Amendment under 37 CFR 1.111
Application No. 10/807,327
Attorney Docket No. 042271

REMARKS

EXPLANATORY FIG. A.

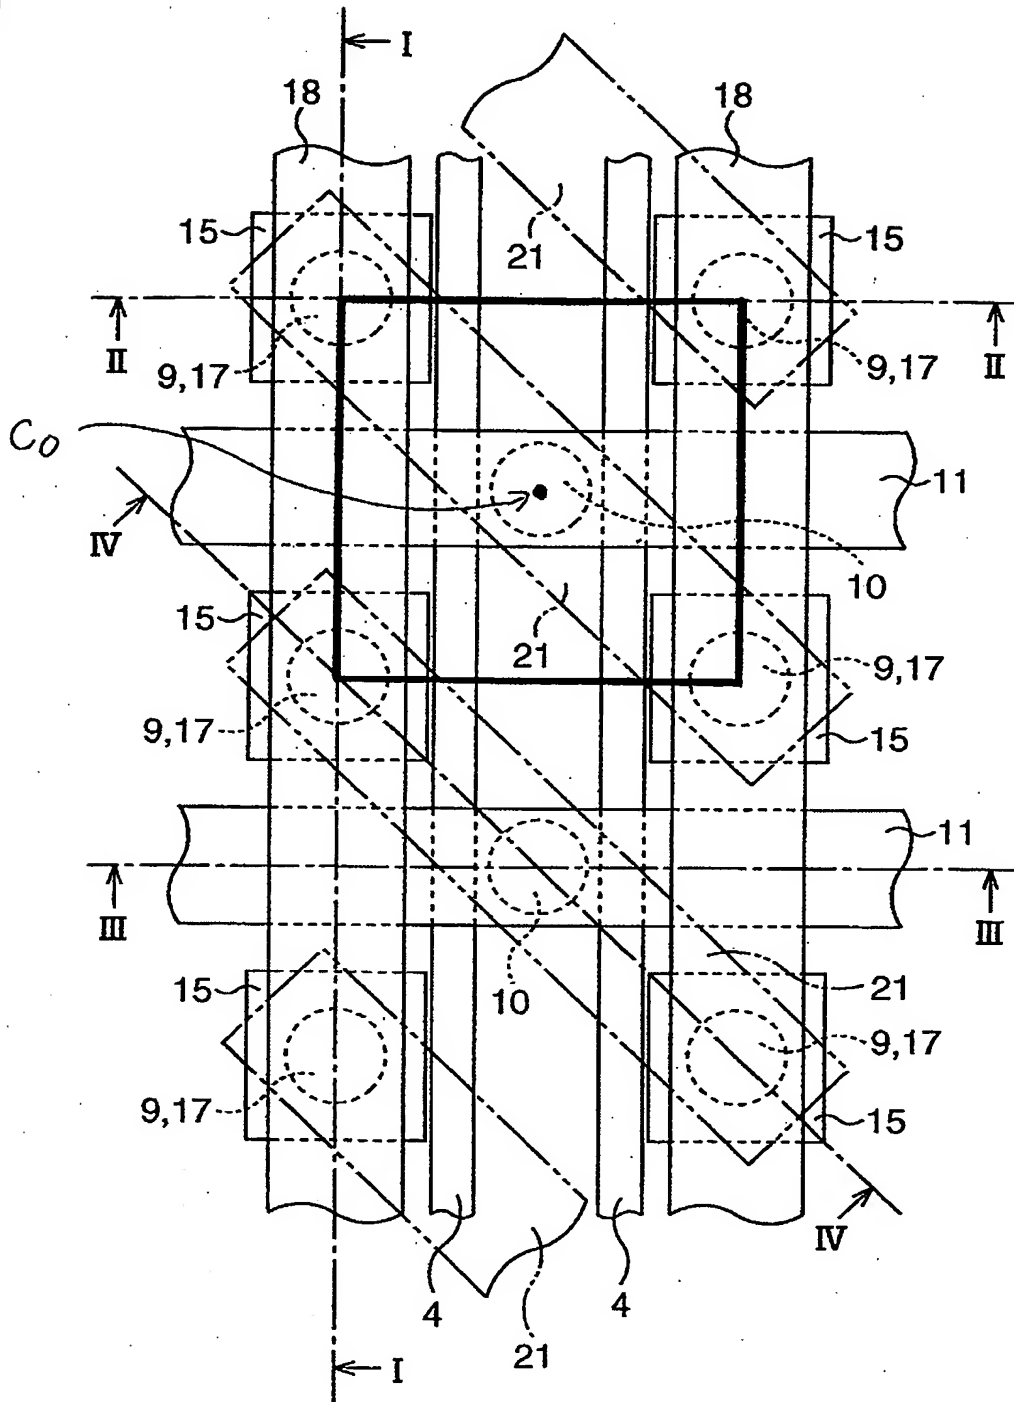
Further explanation is made using attached Explanatory Figures. As shown in Explanatory Fig. A (corresponding to Fig. 2), the area enclosed in the bold line corresponds to "an area surrounded by four closest ferroelectric capacitors . . ." in claim 2. The center C_0 of the enclosed area corresponds to "a center of an area . . ." in claim 2. In the embodiment, the contact plug 10 is located at the center C_0 .
